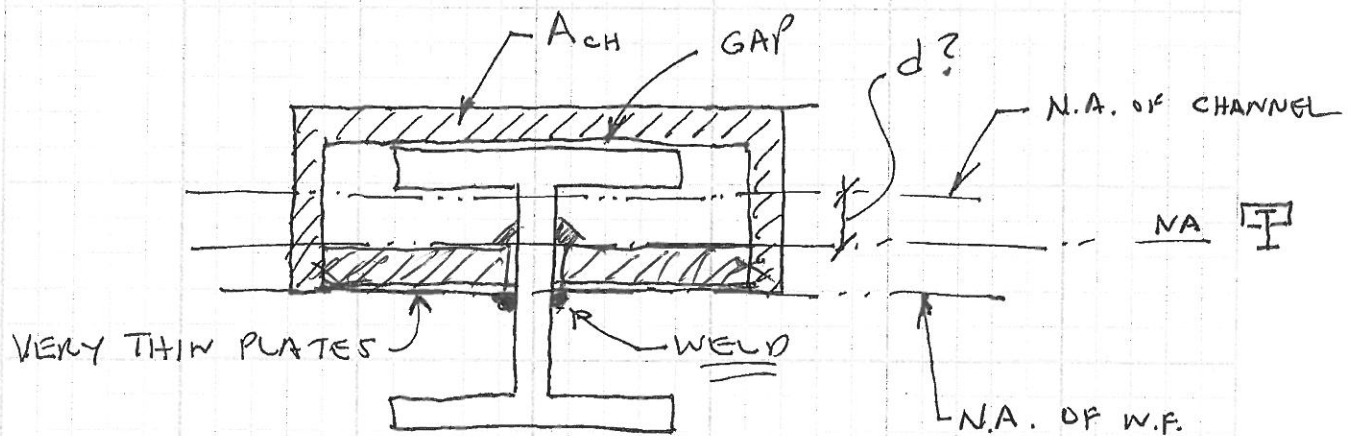
IS THE WELD DESIGN ($q = \frac{VQ}{I}$)
 the same for BOTH?
 i.e. is Q the same?
